SEC Modification Proposal, SECMP0015

GPF Timestamp for Reading Instantaneous Gas Values

Full Impact Assessment (FIA), DCC CR213 and CR1197

Figure 1:Date-time stamp in Grouping Header

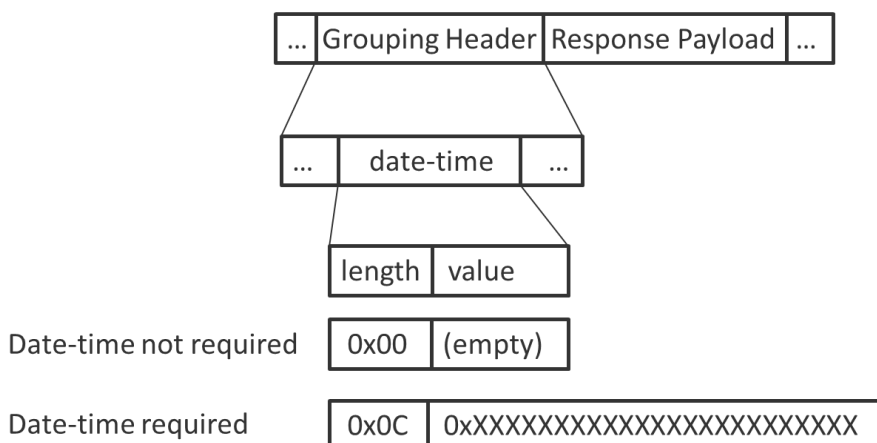
The date-time stamp is part of the Grouping Header defined in GBCS Section 7.2.7 'Message construction – Grouping Header'. GBCS Table 7.2.7 details: 'Where date-time is required for a Message, it shall be a 12 octet string as per the DLMS specification. See 'date-timestamp in response' column, 'Use Case reference' tab in Mapping Table'.

Figure 1 below illustrates the date-time stamp in the Grouping Header.

The settings in the Mapping Table 20 mandate Use Cases GCS13a, GCS13b, GCS13c, GCS14 to include the date-time stamp in the Response; however for the Response to Use Case GCS60 the date-time stamp is currently not mandated.

As a consequence the implementation of SECMP0015 is possible for GCS13a, GCS13b, GCS13c, GCS14 as per the original solution design document; it is not possible for GCS60 due to the date-time stamp being not populated in the Grouping Header.

In order to include the functionality provided by Use Case GCS60 in the solution the following approach shall be taken:

1. Use Case GCS60 shall be deprecated;

2. a new Use Case GCS60a with a new GBCS Message Code shall be introduced;
3. the parameters of Use Case GCS60a shall be those of Use Case GCS60;
4. in addition Use Case GCS60a shall contain a 'Y' in the column 'date-timestamp in response', 'Use Case reference' tab in Mapping Table 20; and
5. Use Case GCS60a shall be added as a new line in Mapping Table 20.
